January 17, 2013 Letting

ADDENDUM NUMBER ONE

FINANCIAL PROJECT NO.: 431714-1-52-01
DISTRICT CONTRACT NO.: EIL13
LEE COUNTY

BRIDGE REPAIR PLANS

SECTION A-A
(View looking upstation)

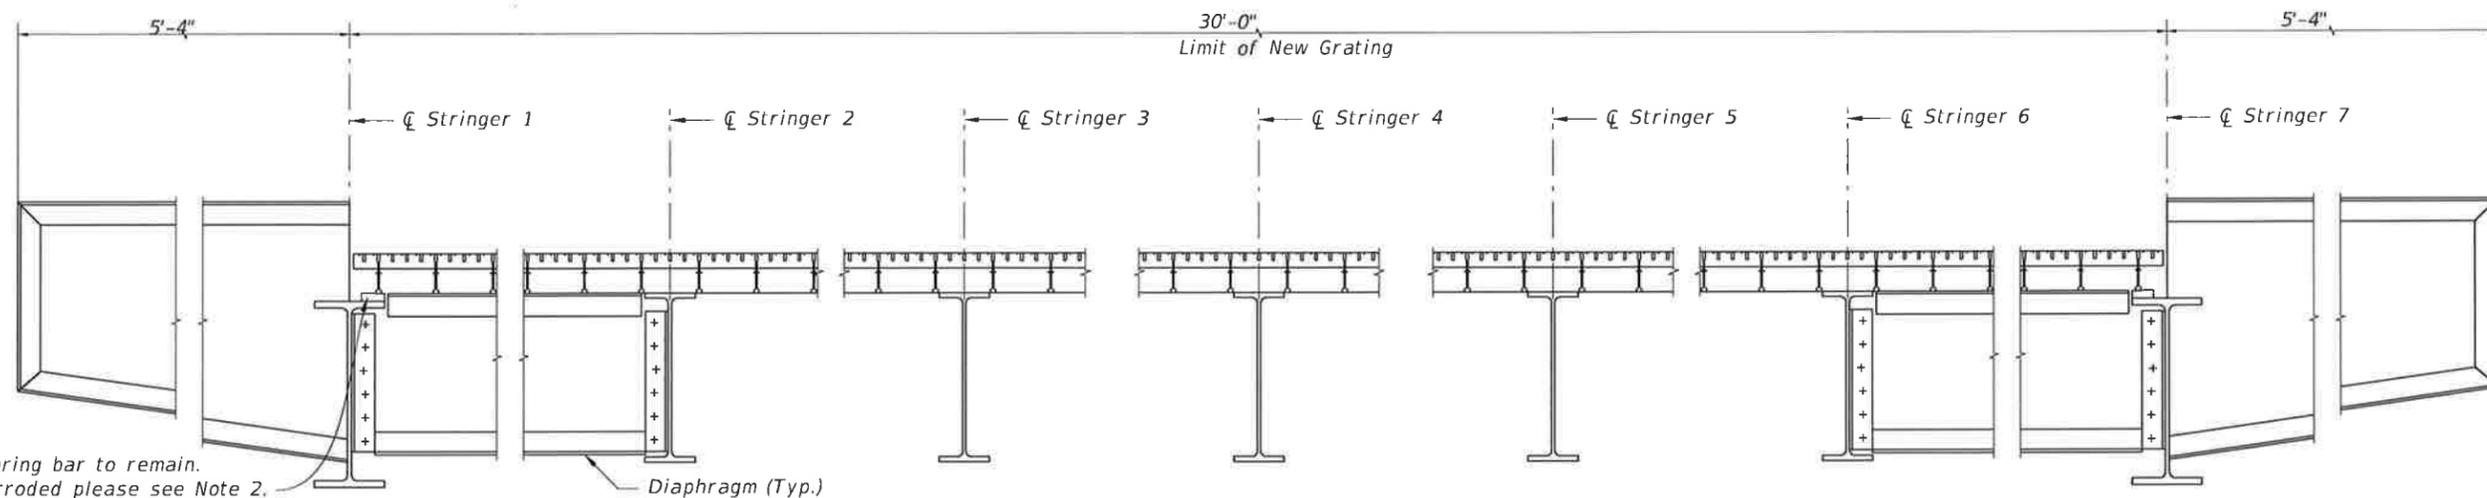
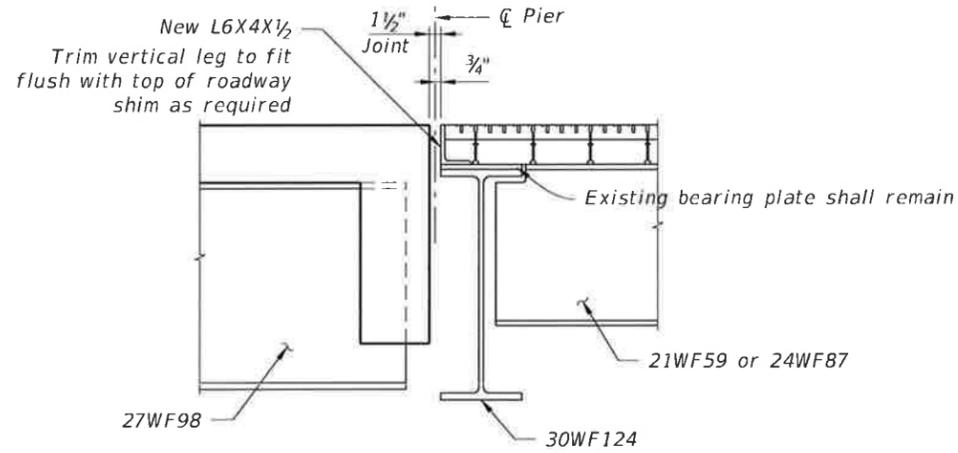
REVISIONS						TY-LIN INTERNATIONAL 12802 TAMPA OAKS BLVD., SUITE 245 TAMPA, FL 33637 TEL. (813) 972-9444 Cert. of Authorization No. 00002017 Boon K. Chong, P.E. 48156	DRAWN BY: DFB 10-12 CHECKED BY: AHA 10-12 DESIGNED BY: FZ 10-12 CHECKED BY: BKC 10-12	STATE OF FLORIDA DEPARTMENT OF TRANSPORTATION			SHEET TITLE: SPAN 2 GRATING DETAILS (1 OF 2)	REF. DWG. NO.
DATE	BY	DESCRIPTION	DATE	BY	DESCRIPTION			ROAD NO.	COUNTY	FINANCIAL PROJECT ID		
12/31/2012	BKC	Revision addendum 1 - Adjust steel grating and restripe the grating.					80	LEE	431714-1-52-01

Existing Bearing bar to remain.
If bar is corroded please see Note 2.

1. Section A-A and Section B-B are taken from plan view on see Sheet 11.
2. If the bearing plate is found to be corroded, it shall be ground to top flange of stringer. Contractor shall provide new bearing plate with counter sunk bolt connection at 6" spacing and stagger at 2" spacing laterally. Bearing plate size and thickness shall be field measured.
3. The Contractor shall provide all necessary methods to level the steel grating to adjacent concrete span elevations. This method may include, but is not limited to, the selection of steel grating height, adding shim plates at the bearing by jacking, or grinding of the bearing plates. The Contractor shall submit all adjustment plans to the Engineer for approval.
4. The Contractor shall provide new traffic striping on the steel grid deck after installation.
